## **BULLETIN NO. 090819**

**PRODUCT:** Q90-50/75/100 Boilers

**TITLE:** New Inducer motor/blower assembly

PHOTO 3: Flue pipe clearance

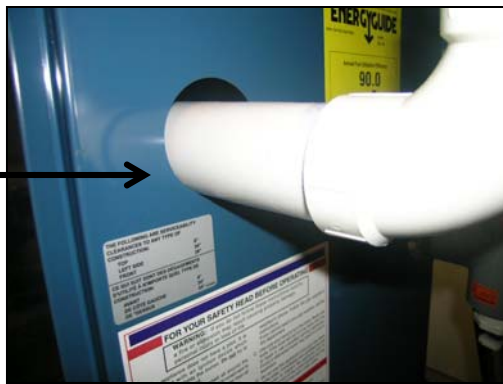
- The inducer must not be allowed to support the weight of the PVC vent pipe. The vent pipe must be properly supported with brackets or pipe hangers secured to the structure.
- Check for vibration transmission between the flue pipe where it passes through the boiler jacket. Contact at the jacket penetrations can transmit unwanted sound transmission. See photo 3.
- When penetrating the side wall, always be sure to leave enough room for expansion and contraction of the vent pipe. 1/8 to 1/4 inch clearance around the pipe is recommended with a thin layer of sealant to seal the opening if required. See photo 4.

Flue pipe resting on boiler jacket can transmit inducer sound.
